Rezoning Transportation Analysis

Petition Number: 2020-168

General Location Identifier: Tax ID 10110157

| Date | Description |
|----------|--------------------|
| 12-28-20 | First Review (WB) |

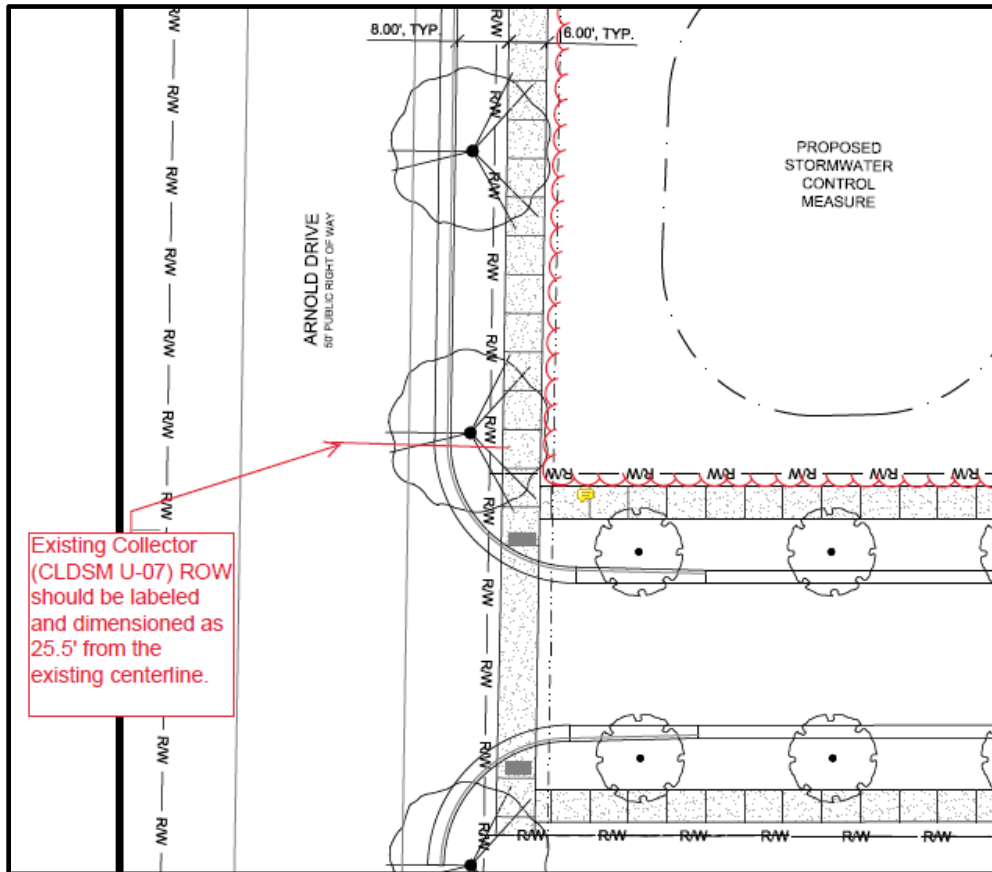
1. **Curbline:** The proposed zoning district has a setback measured from back of the existing or proposed future curbline.
 - a. **Arnold Drive:** The curb and gutter needs to be installed at 17.5 feet from the road centerline.

Label and dimension the curb and gutter from the centerline for each road to the back of curb on the site plan.

3. Revise site plan and conditional note(s) to commit to dedicating 25.5 feet of right-of-way, to be measured from the road centerline. Label and dimension the right-of-way from the road centerline.
